STORM SEWER IMPROVEMENTS to serve **VERANDAS AT CRESTVIEW APARTMENTS** 300 NORTH 127TH STREET EAST CITY OF WICHITA, KANSAS, 67206

Project Number
 2021-000671PPD (ORG CODE 56030970)

PPD PLAN

CU711

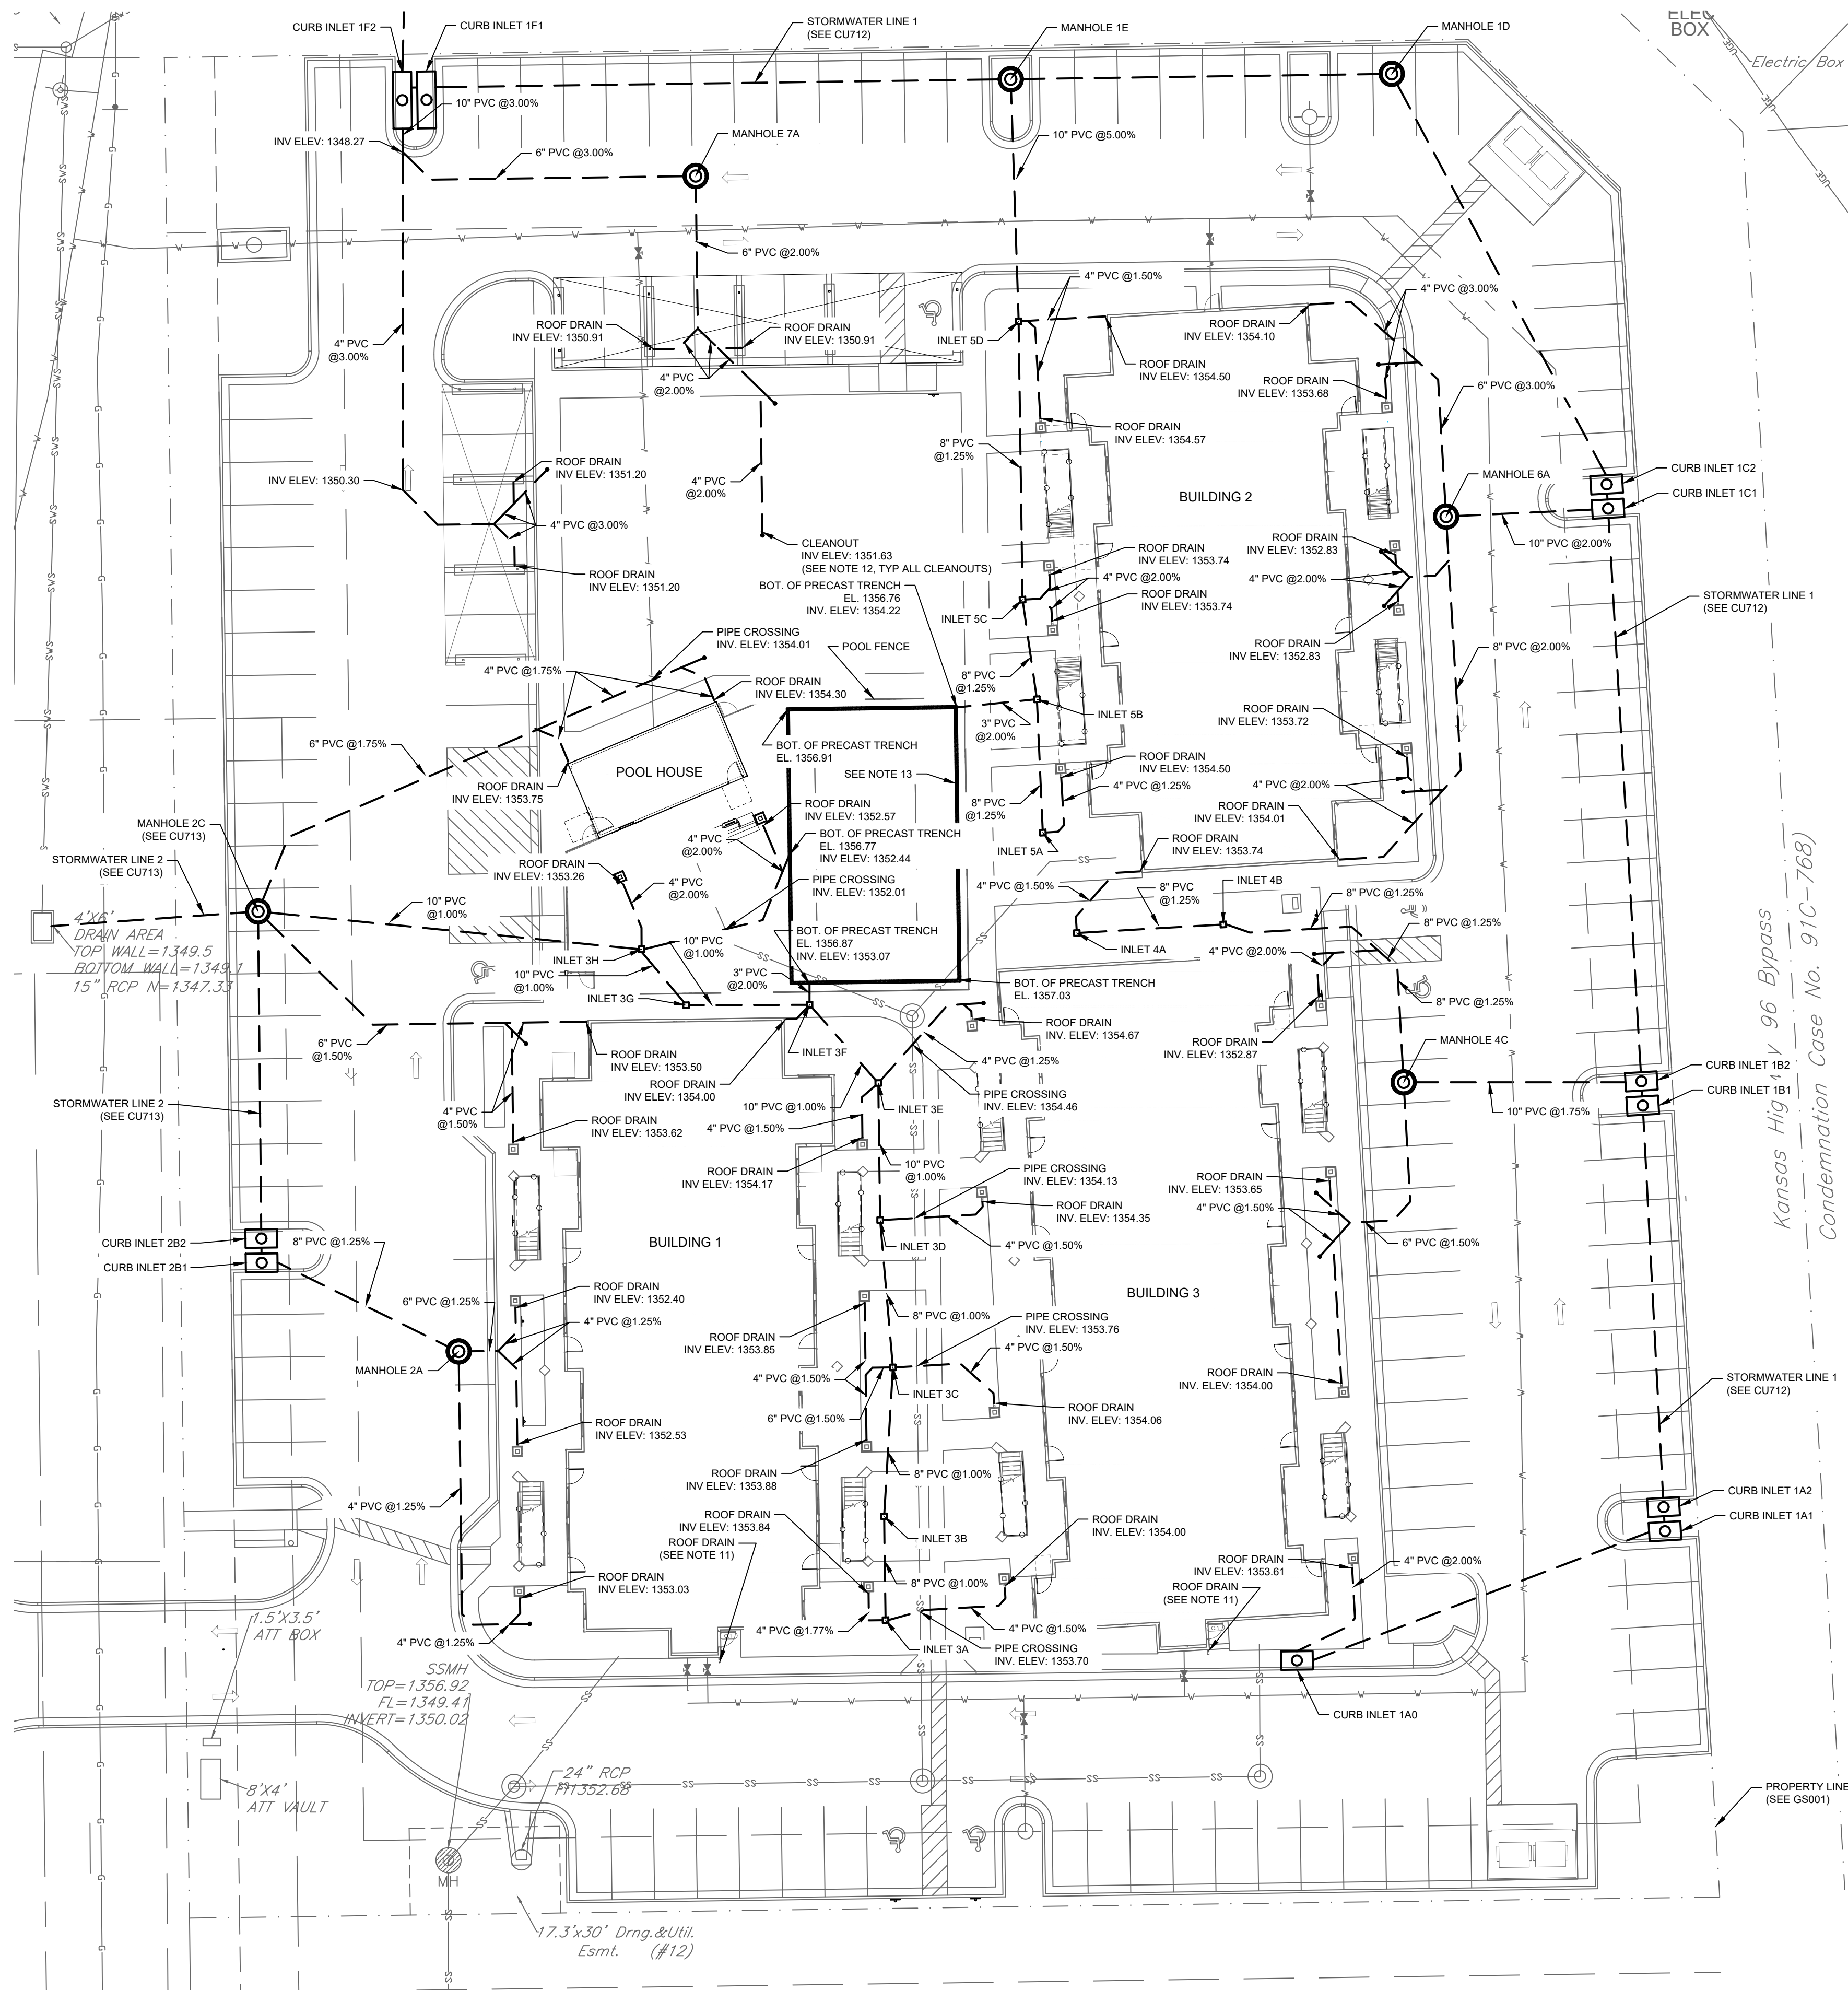
EXTENSIVE REVISIONS:
 1. ADDED NOTE 14 PER MABCD COMMENTS.
 2. ADJUSTED PIPE INVERT ELEVATIONS TO MATCH NEW STORMWATER DESIGN (SEE CU712 AND CU713).
 3. ADJUSTED ROOF DRAIN TO TIE INTO CURB INLET 1A0 AS OPPOSED TO CURB INLET 1A.

2 PPD PLAN - STORMWATER LINE 1
 1" = 40'-0"

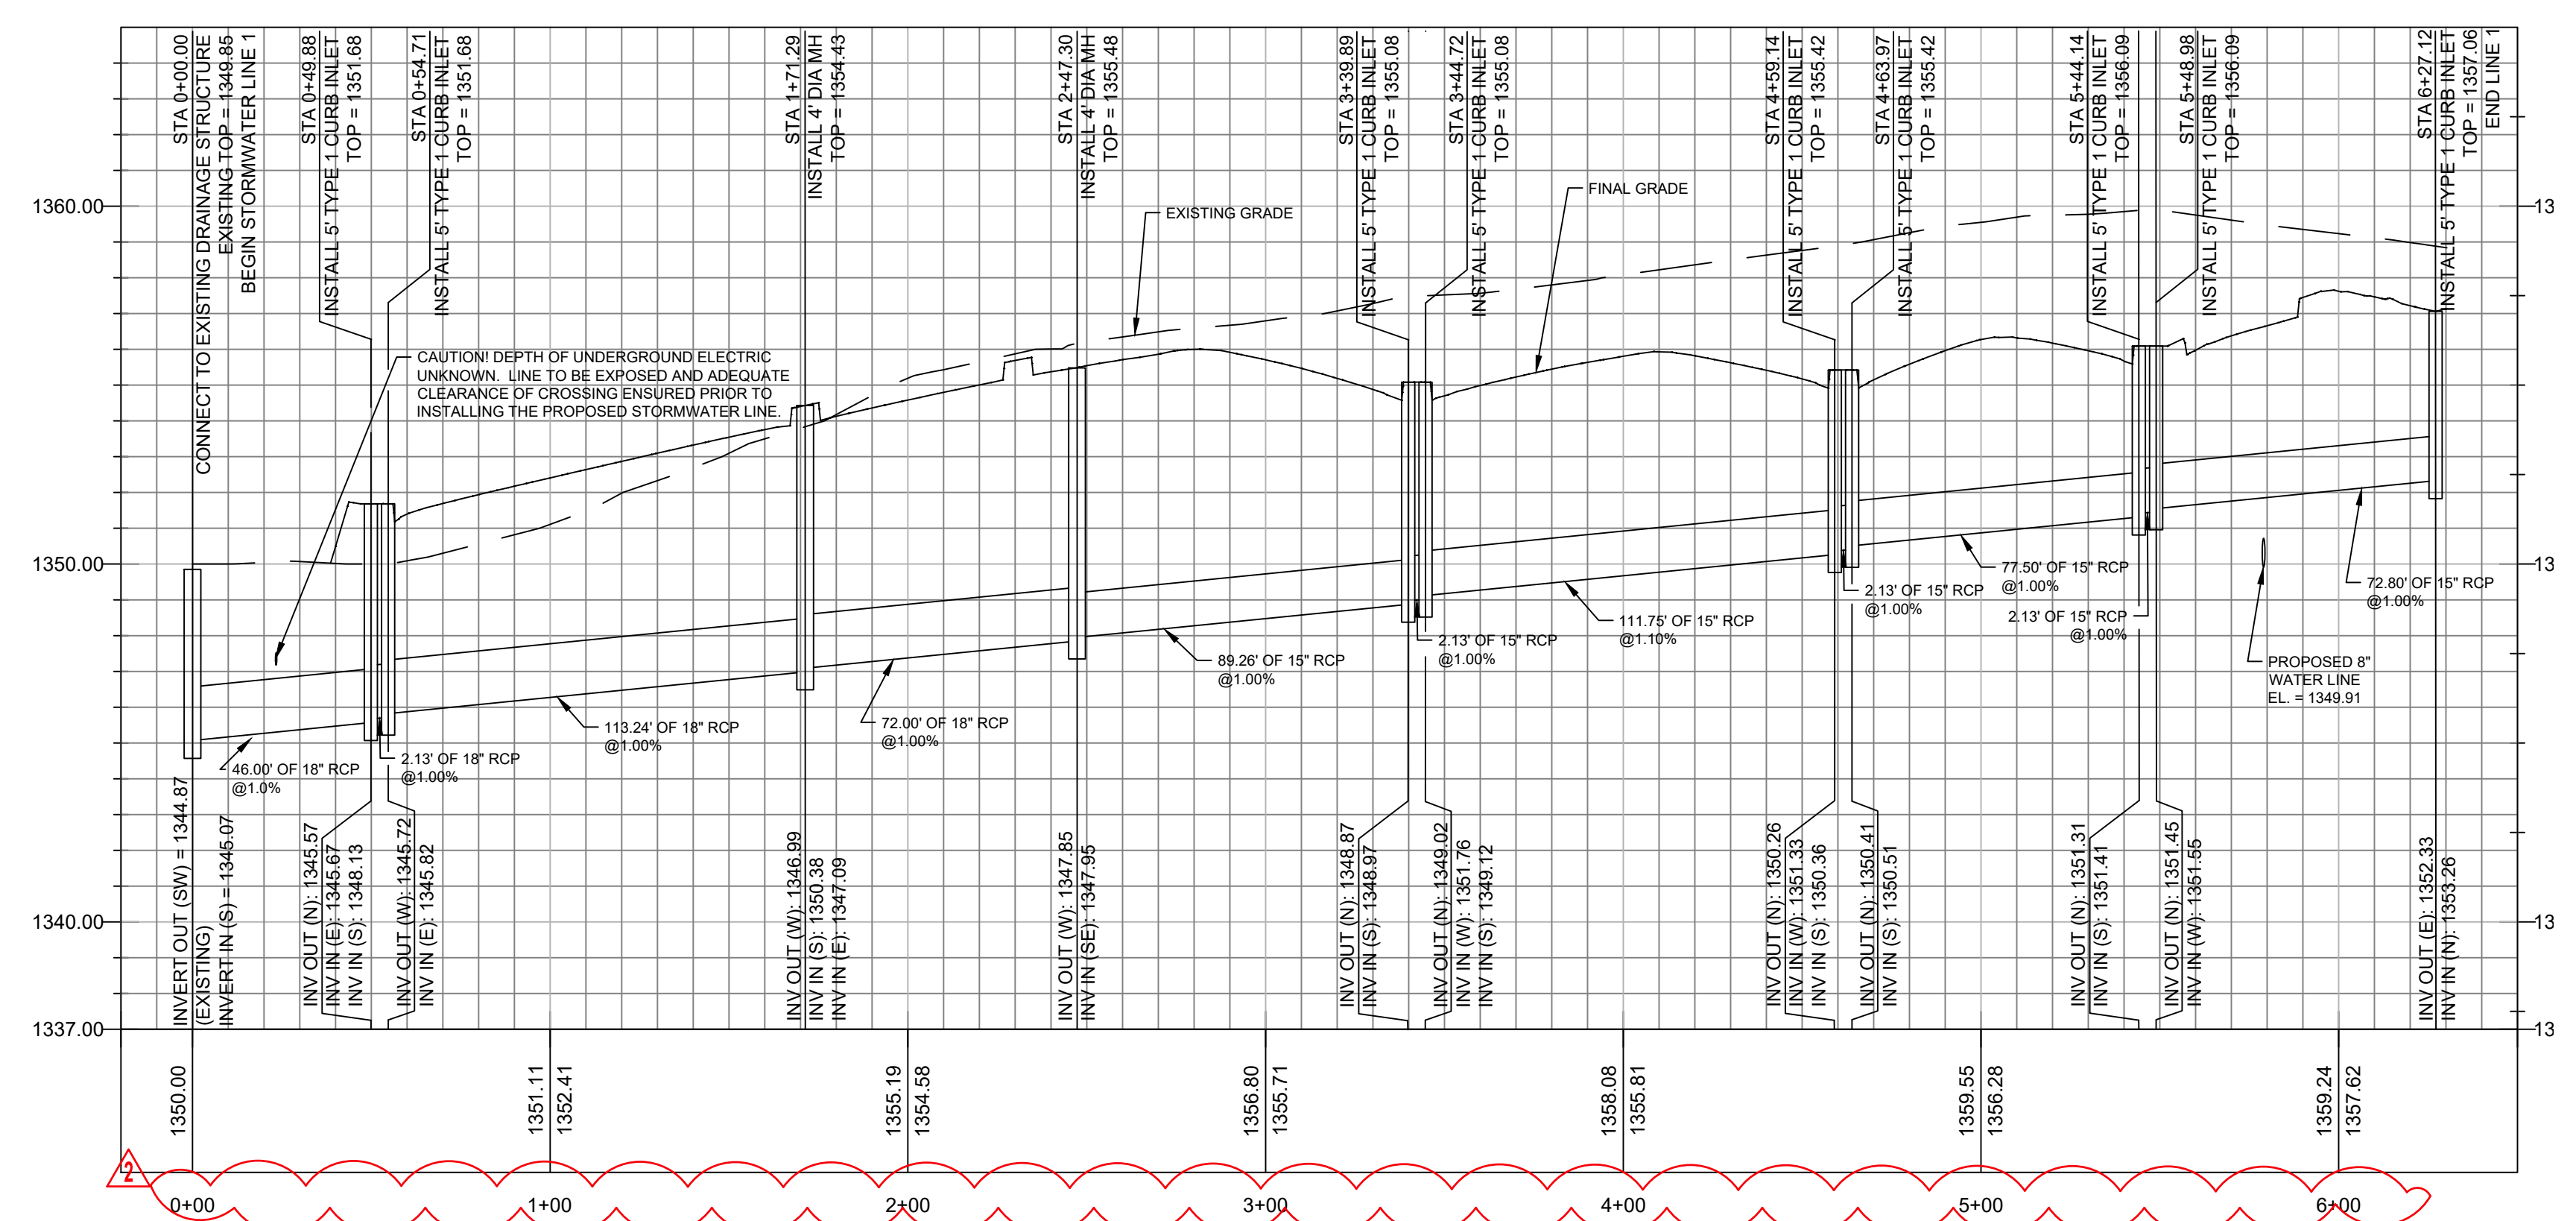
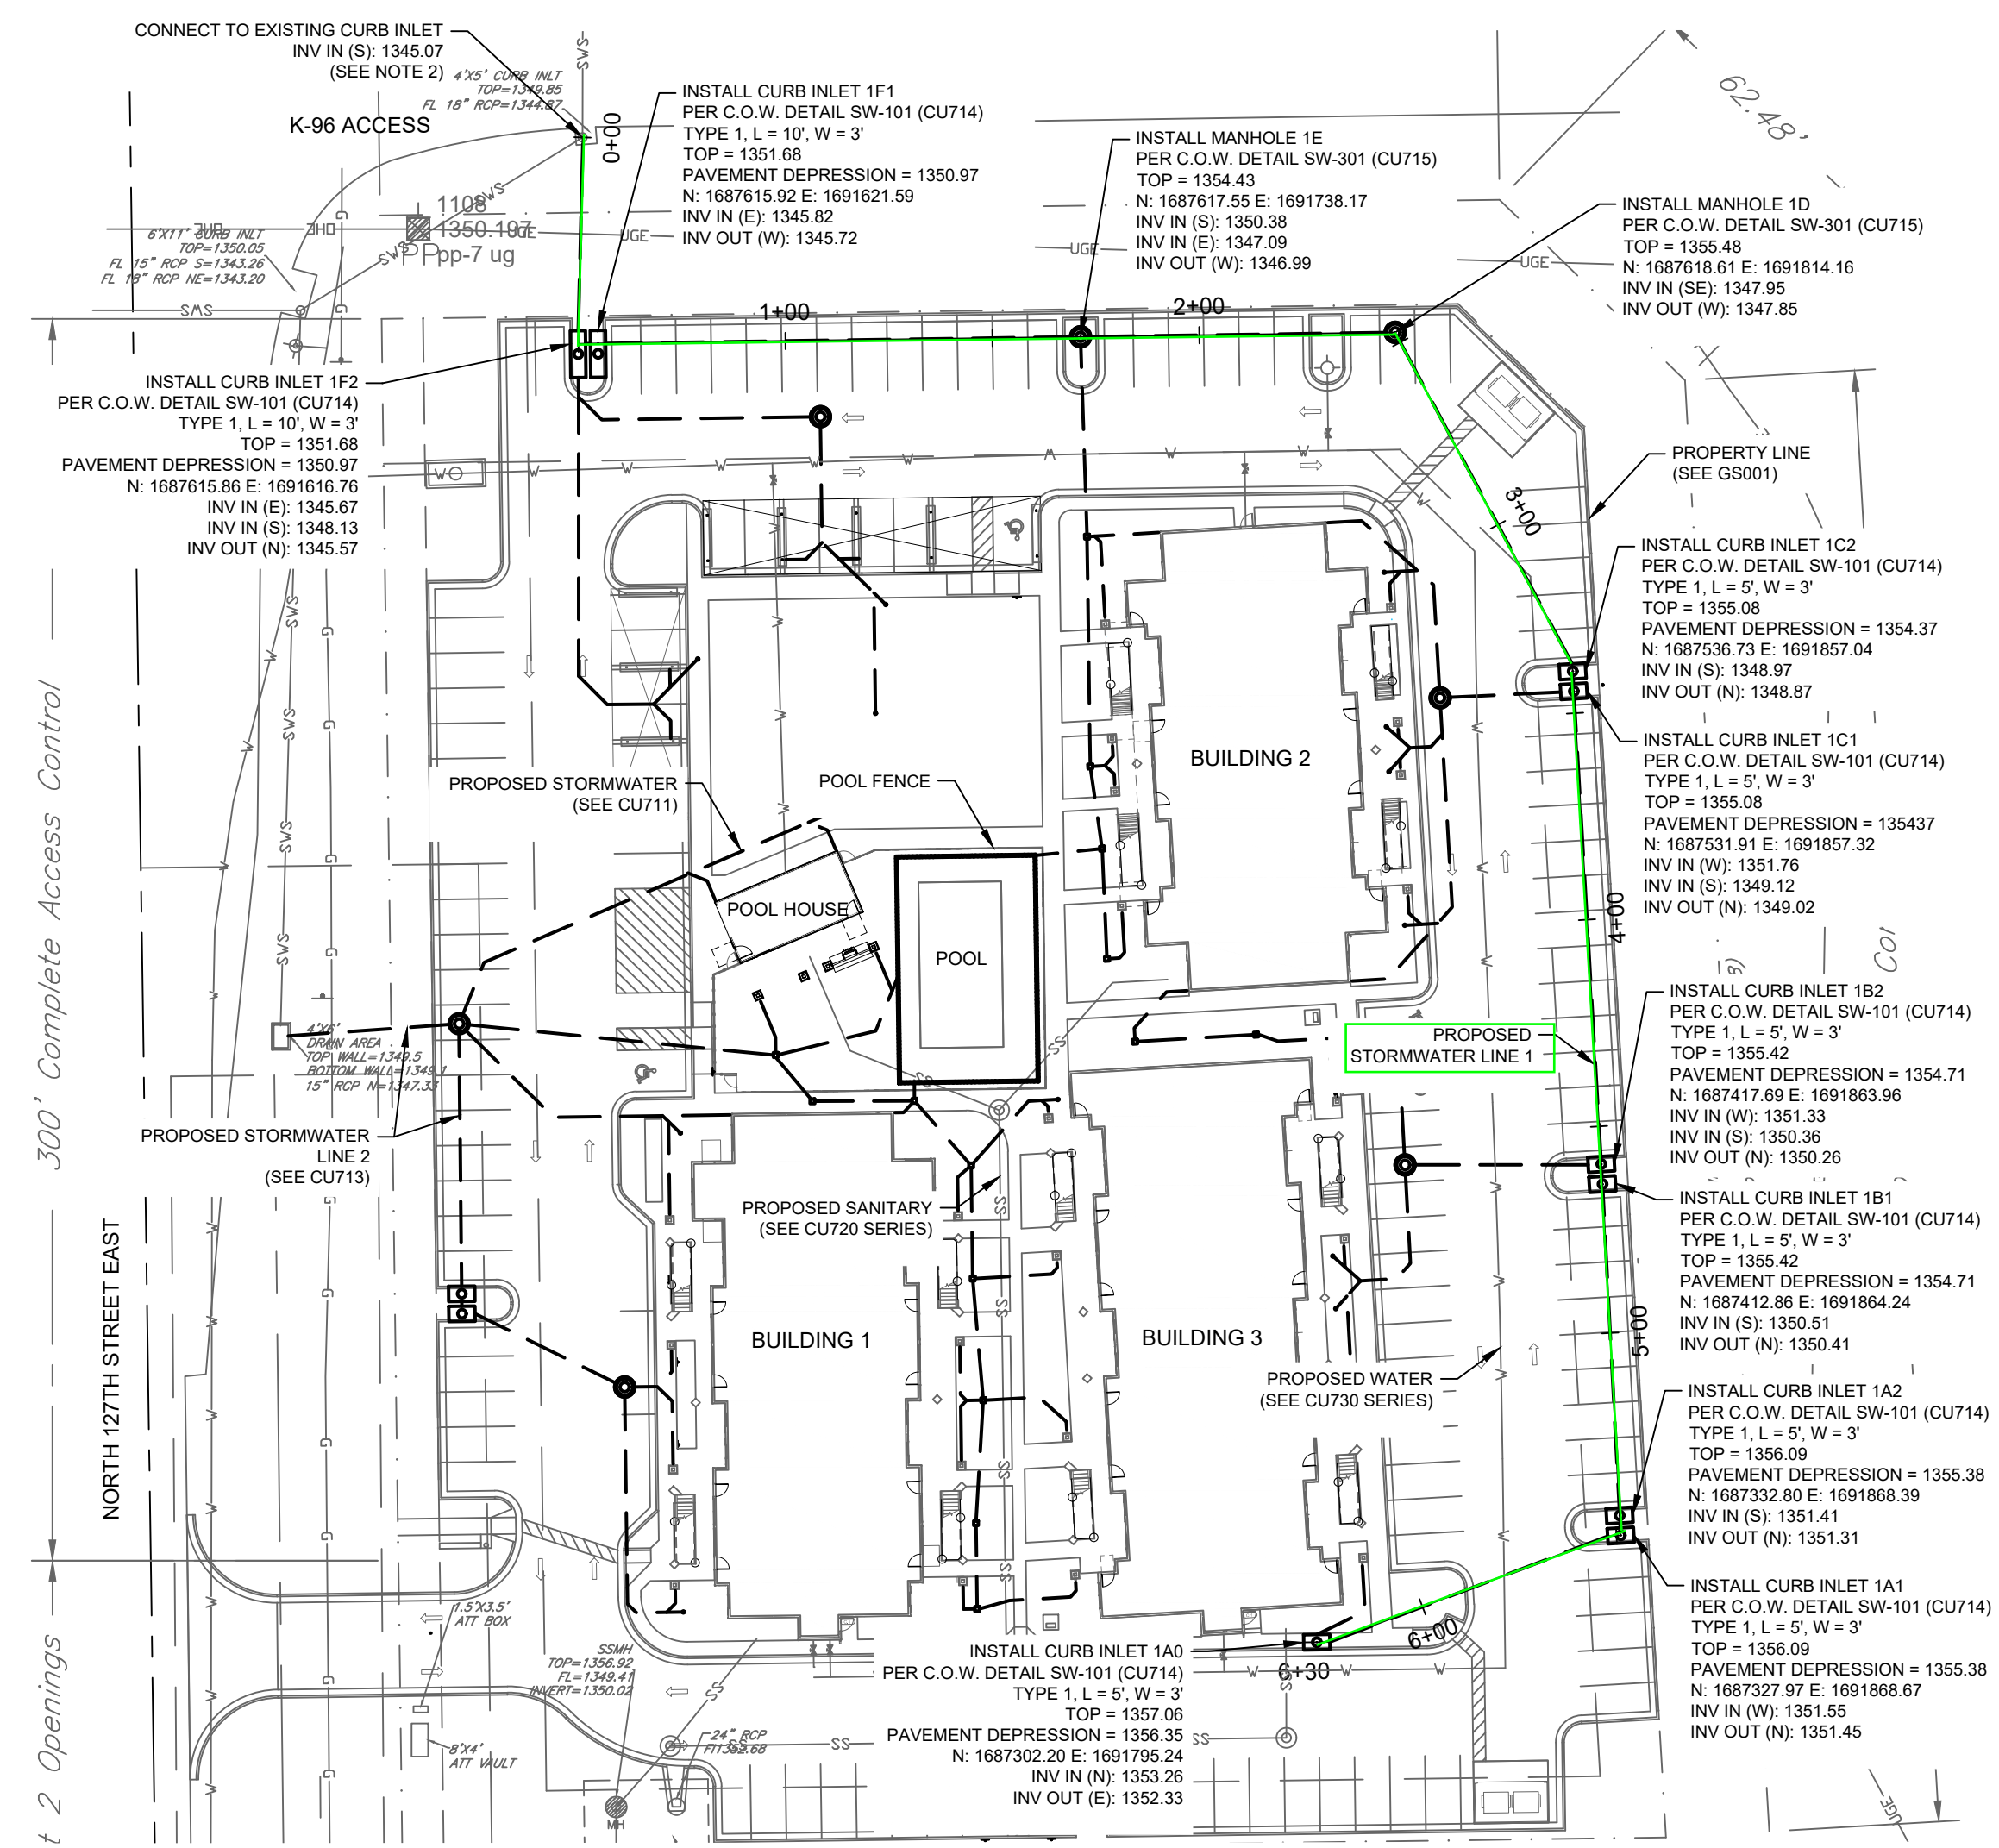
EXTENSIVE REVISIONS:
 1. ADDED CURB INLET 1A2, 1B2, 1C2, AND 1F2 TO KEEP ALL INLETS WITHIN PROPERTY LIMITS PER KDOT COMMENTS.
 2. MANHOLE 1D AND 1E WERE PREVIOUSLY CURB INLETS.
 3. ADDED CURB INLET 1A0 IN ORDER TO KEEP GRADING EXTENTS WITHIN SOUTH PROPERTY LINE.
